North American Tungsten Corporation Limited

RESPONSE TO YESAB'S ADEQUACY REVIEW REPORT
OF SUPPLEMENTARY INFORMATION RESPONSE
FOR THE PROPOSED MACTUNG MINE, MACMILLAN PASS, YUKON
(YESAB PROJECT NUMBER: 2008-0304)

ADDENDUM 2 OF THE MACTUNG PROJECT PROPOSAL

EBA FILE: W23101211.002

Figure 1.7

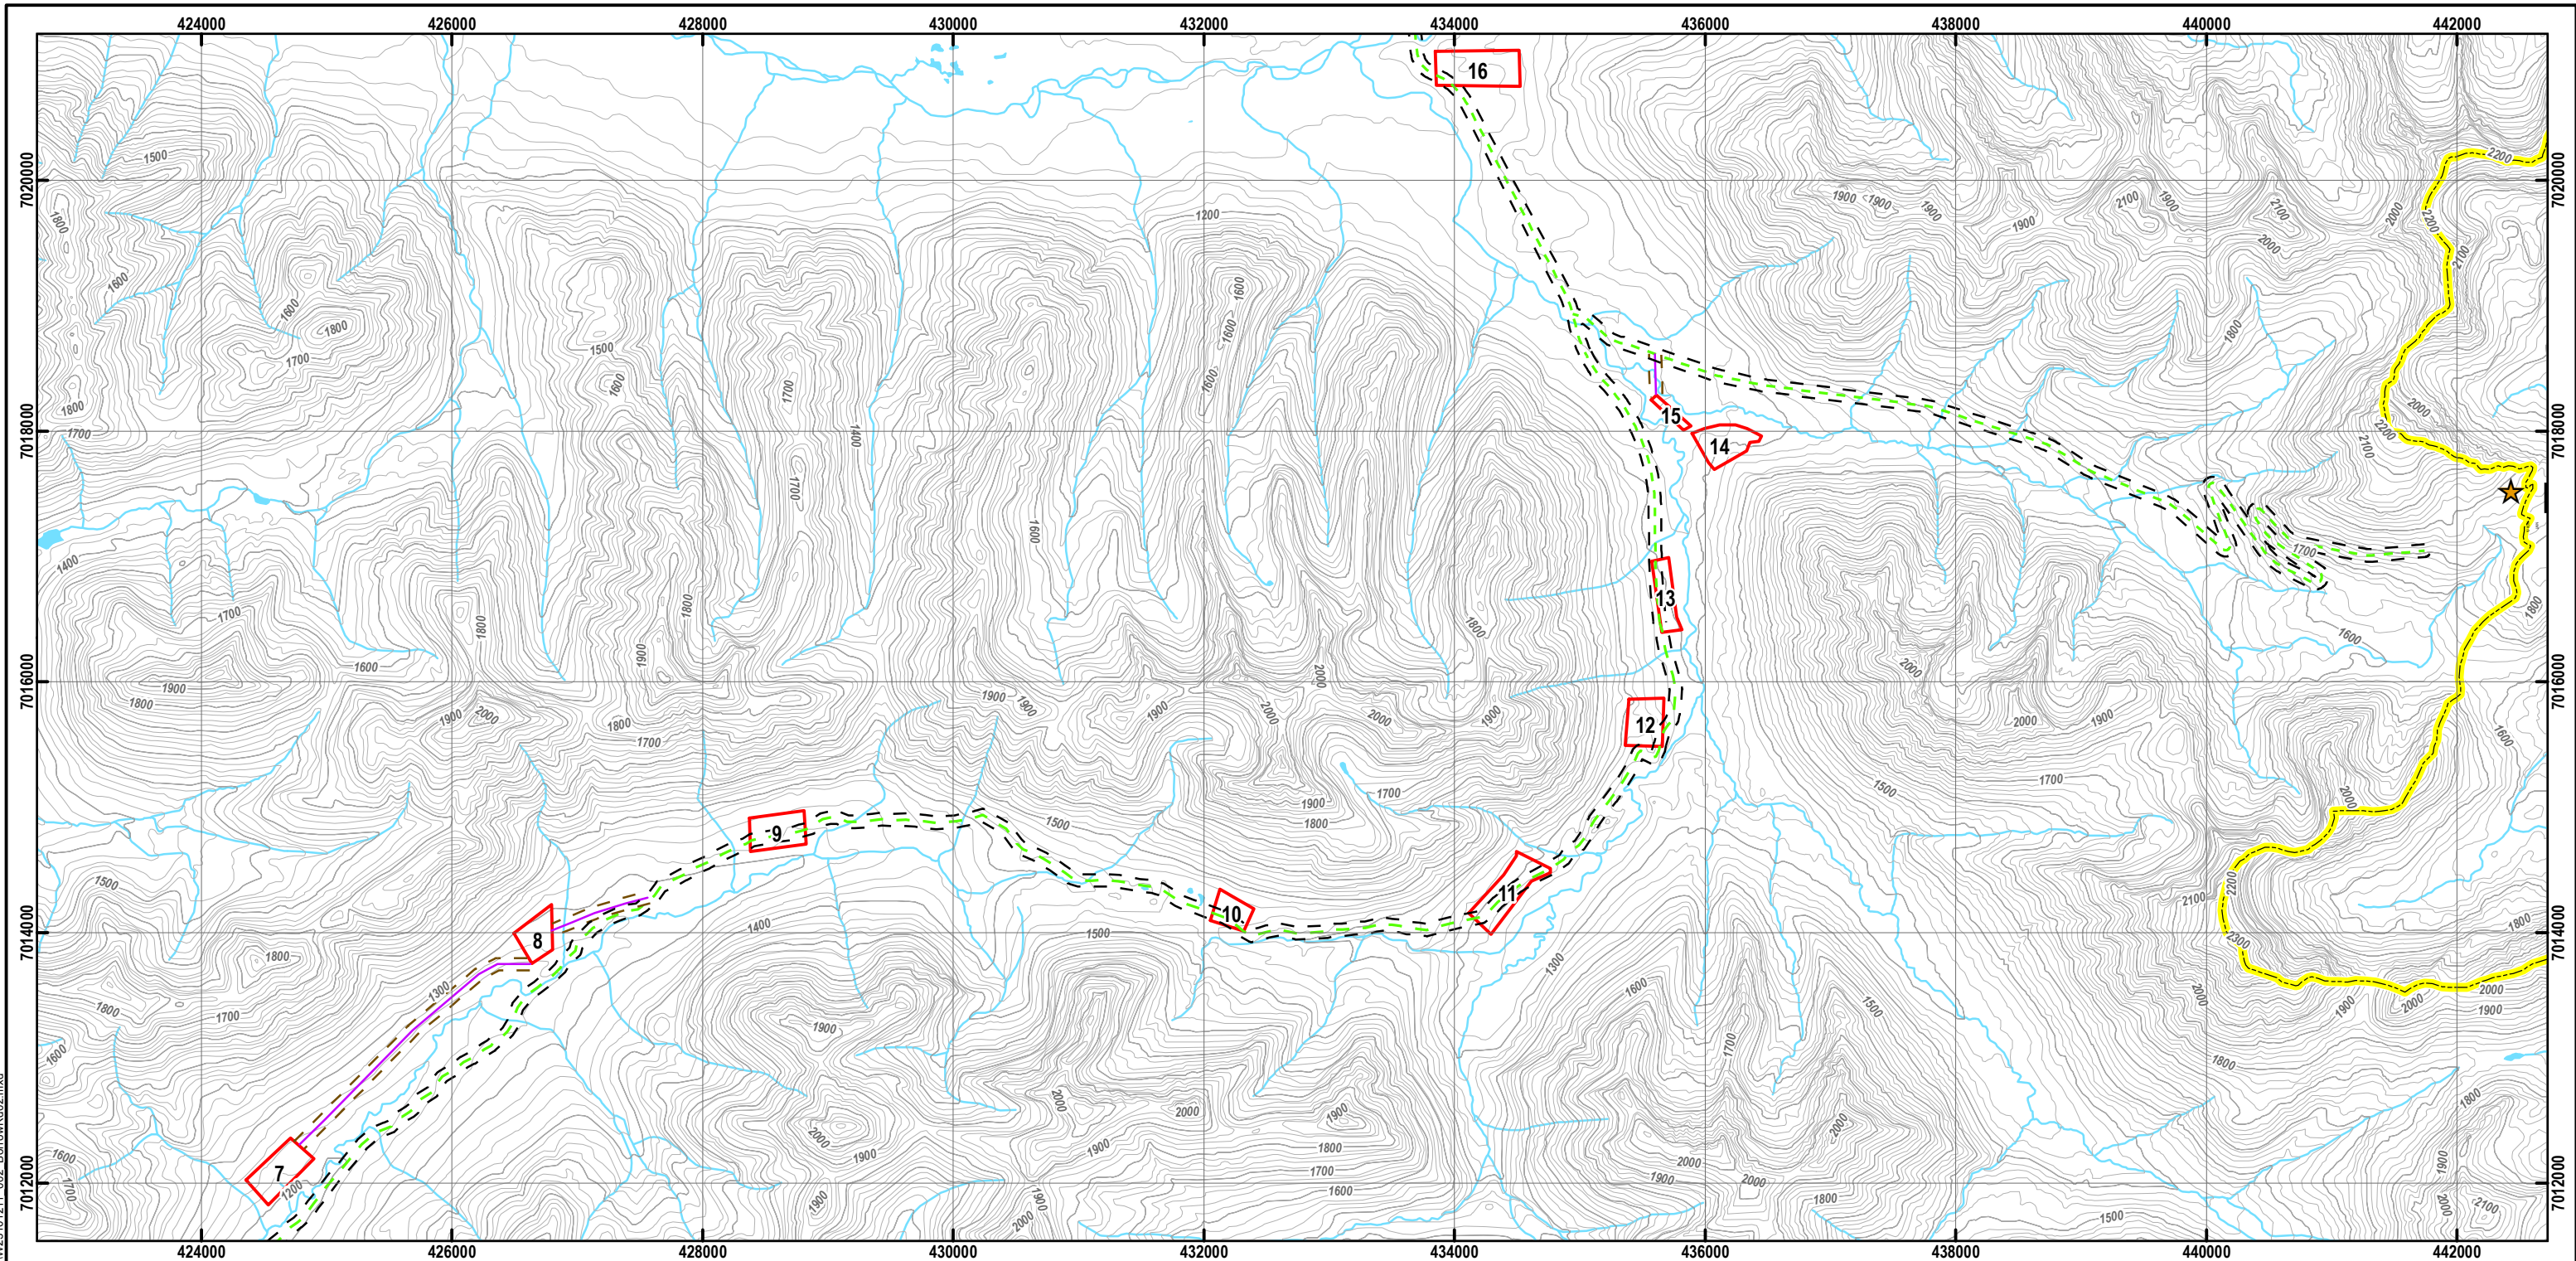
- b) Provide the proposed access on the route map where additional access will need to be constructed for the borrow sources identified in Figures 3.1.1-1 and 3.4.1-2 (Response to Adequacy Review Report).

Please refer to Figures 1.6-1.7, contained within Appendix B, for a presentation of borrow sites and their proposed access routes. It should be noted that borrow sites 1, 2, 9, 10, 11, 12, and 13 overlap with the proposed road right-of-way and therefore will not require the development of access roads. Further, borrow sites 7, 14, and 15 may have more complex access requirements due to their physical location. For this reason NATC will consider these borrow sources as provisional. These sites will only be developed if the necessary material cannot be sourced from the other borrow pits in the area of road construction. As stated in Addendum 1, NATC has identified more borrow resources than it anticipates will be required.

As presented in Figure 1.7, access to borrow site 7 would be developed from borrow site 8. Access to borrow sites 14 and 15 would require a stream crossing across at Tributary A.. This would be done by installing the appropriate size culvert; the method for culvert sizing and installation has been outlined in the Project Proposal. The development of these sites would be done only if absolutely necessary and would be completed only after freshet. It is expected that these borrow sites would be utilized for one season after which the site would be reclaimed and the culvert removed.
